Subject: Transmittal of Revision 1 To Service Bulletin Number
V25000-ENG-72-0364.

- (1) Incorporate intent of EC 98VC016N.
- (2) Delete Concurrence Requirements.
- (3) To Add dimensions to Illustrations.
- (4) Editorial corrections.
- (5) To Update Material Information.
- (6) To Update Family Trees.

ENGINE - HIGH PRESSURE TURBINE - PROVIDE NEW STAGE 2 HIGH PRESSURE
TURBINE DUCT SEGMENTS

ENGINE - HIGH PRESSURE TURBINE - PROVIDE NEW STAGE 2 HIGH PRESSURE
TURBINE DUCT SEGMENTS

Location of the Stage 2 High Pressure Turbine Duct Segments And Support
Figure 1

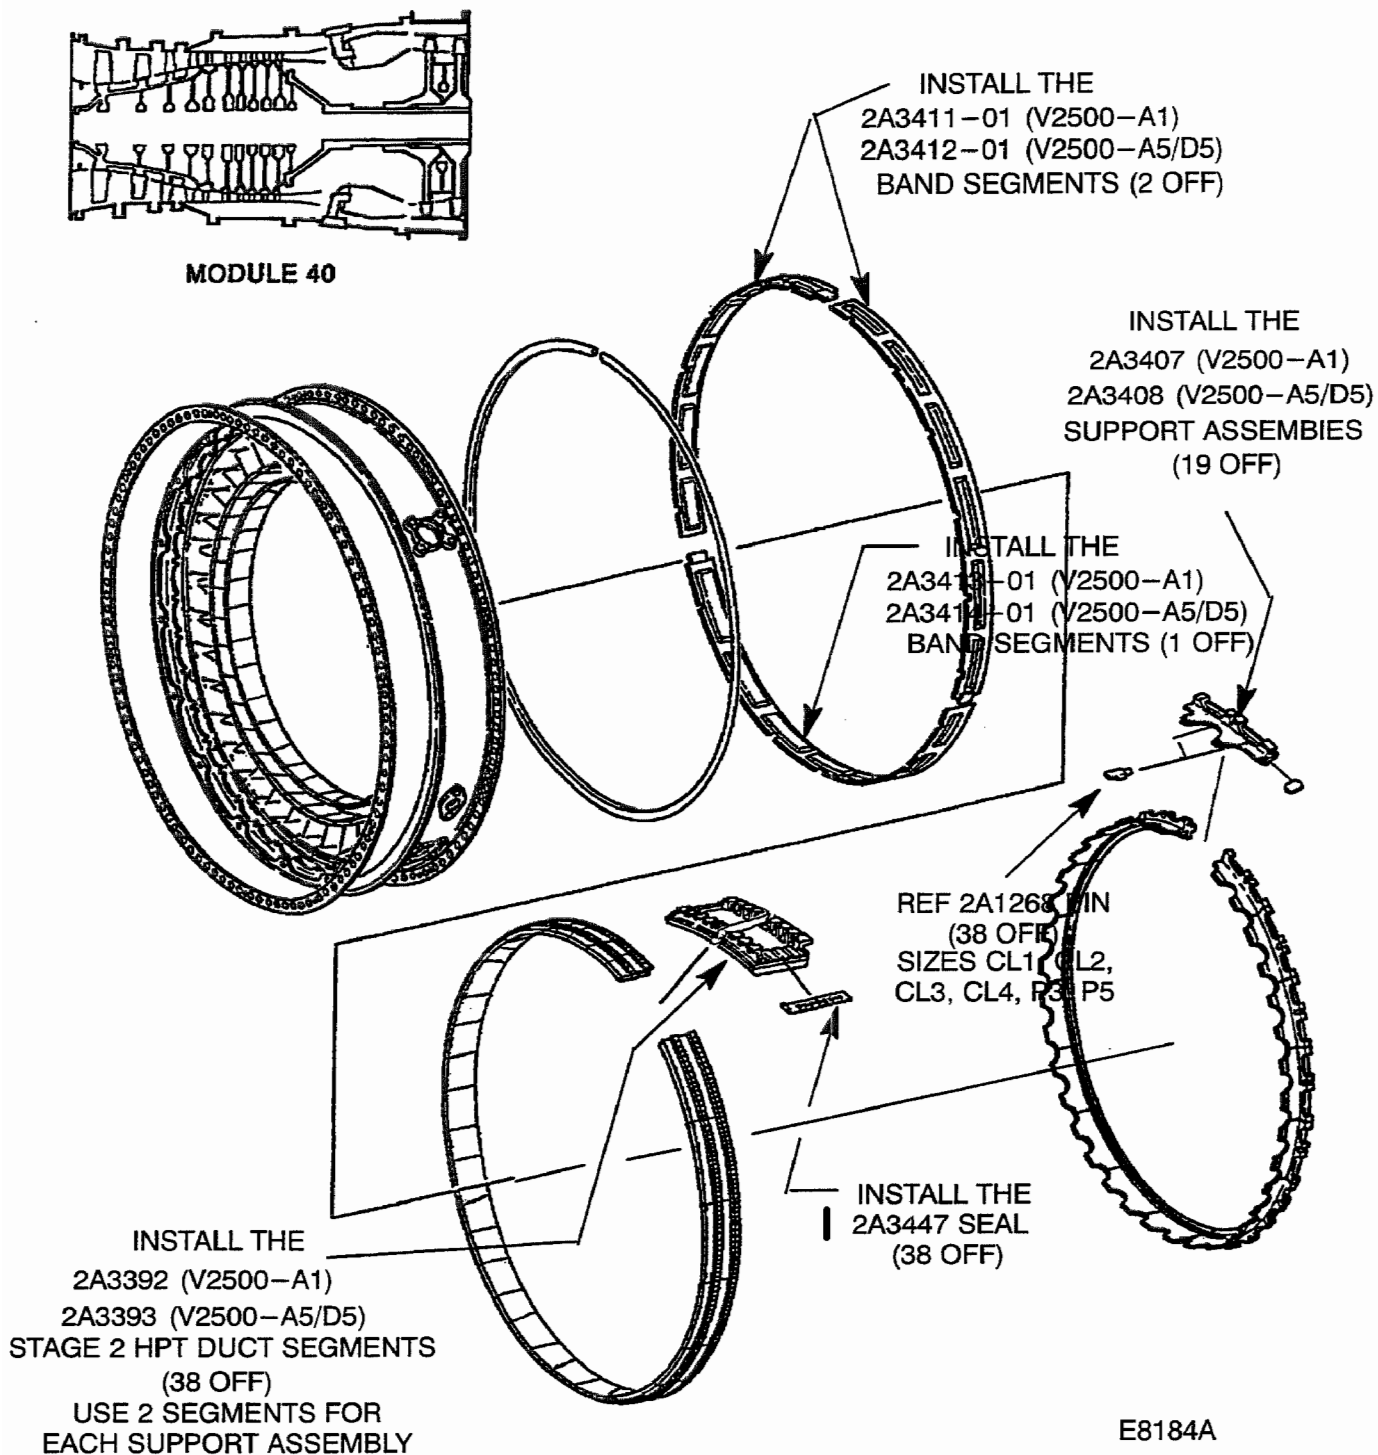
- (1) Assemble the following by the procedure specified in Reference (2) or (3), Chapter/Section 72-45-20 Assembly-01. See Figure 1.
- (a) Stage 2 High Pressure Turbine Duct Segments (38 off), 2A3392 (V2500-A1) or 2A3393 (V2500-A5/D5).
NOTE: This configuration requires 38 Duct Segments.
- (b) Seal (38 off) 2A3447.
NOTE: This configuration requires 38 Seals.
- (c) Support Assembly (19 off), 2A3407 (V2500-A1) or 2A3408 (V2500-A5/D5).
- (d) Band Segments 2A3411-01 (2 off) and 2A3413-01 (1 off) (V2500-A1) or 2A3412-01 (2 off) and 2A3414-01 (1 off) (V2500-A5/D5).
- (2) Do not do the grind procedure specified in Reference (2) or (3), Chapter/Section 72-45-20, Assembly-01. See the applicable subtask for the particular engine model.
- NOTE:** The new Stage 2 High Pressure Turbine Duct Segments are finish machined at manufacture eliminating, the need to machine (grind) at assembly.

Modification of the Stage 2 High Pressure Turbine Duct Assembly
Figure 2 (Sheet 1 of 2)

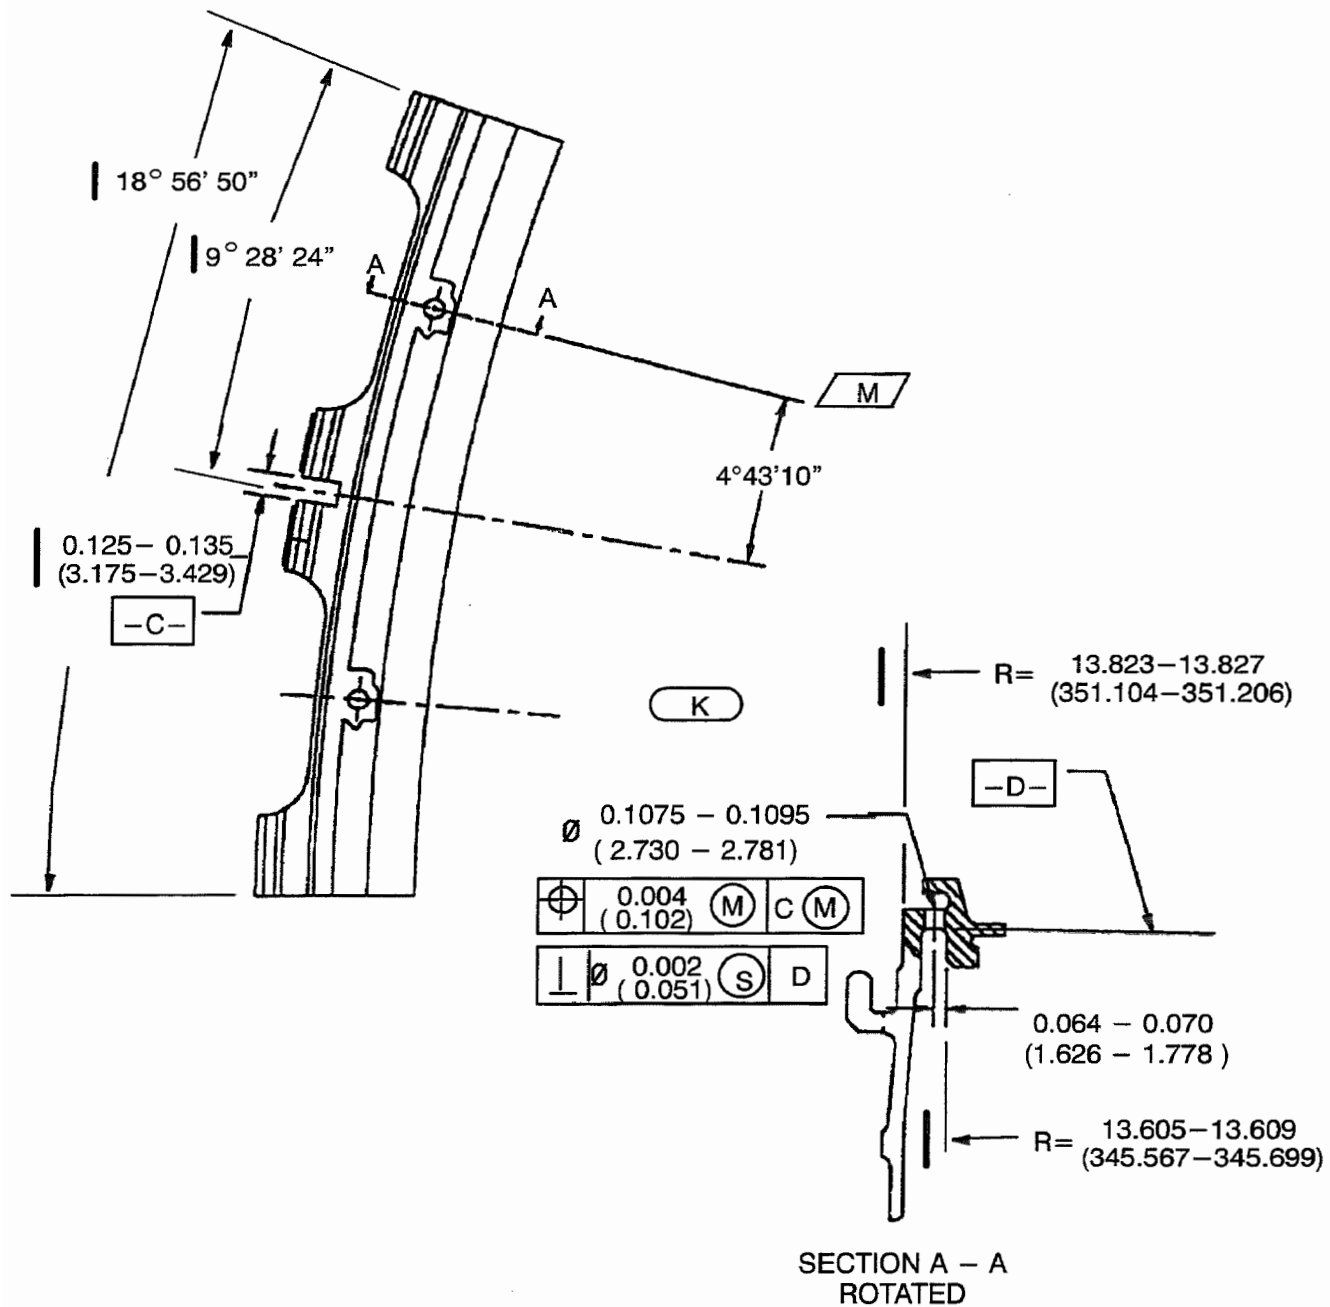
- (1) Do a modification of the 2A1653 or 2A2270 Stage 2 HPT Support Assembly (1 off). See Reference (1), Chapter/Section 72-45-26, Figure/Item No. 01-020. See Figures X and Y.

- | | | | | | | | |
|--|---|-----------------|------------------------|--------|--------|--------|--------|
| (a) Drill Hole. | Refer to Figure 2 (Sheet1) Section A-A | | | | | | |
| (b) Select (Class 1-4, P3, P5) Pin Part Number 2A1268 (1 off) to obtain a 0.0005T - 0.0015T (0.0.013T - 0.038T) Fit. | Refer to Figure 2 Sheet 2). | | | | | | |
| (c) Install the Pin Part Number 2A1268 (1 off) in the 2 HPT Support Assembly. | Refer to Figure 2 (Sheet2).
Note: 1 Pin is required for each Duct Segment | | | | | | |
| (d) Mark the new part number adjacent to the existing part number. Use the vibration peen method. |

Use the procedure specified in Reference (6), Chapter/Section 70-09-00, Marking of Parts. See Figure Z. | <u>Existing</u> | <u>New Part Number</u> | 2A1653 | 2A3408 | 2A2270 | 2A3407 |
| <u>Existing</u> | <u>New Part Number</u> | | | | | | |
| 2A1653 | 2A3408 | | | | | | |
| 2A2270 | 2A3407 | | | | | | |

Modification of the Stage 2 High Pressure Turbine Duct Assembly
Figure 2 (Sheet 2 of 2)

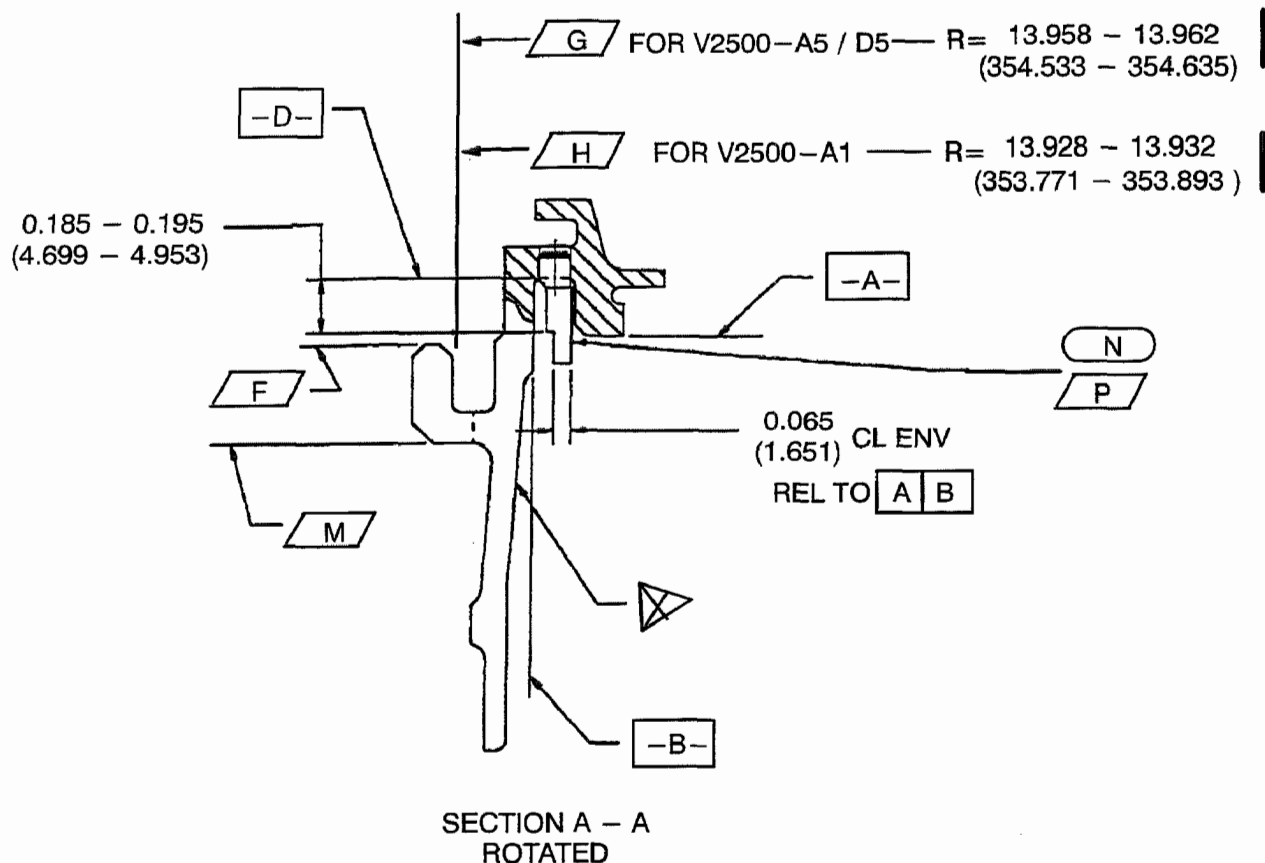
N SELECT CLASS TO OBTAIN 0.0005T – 0.0015T (0.013T – 0.038T) FIT.
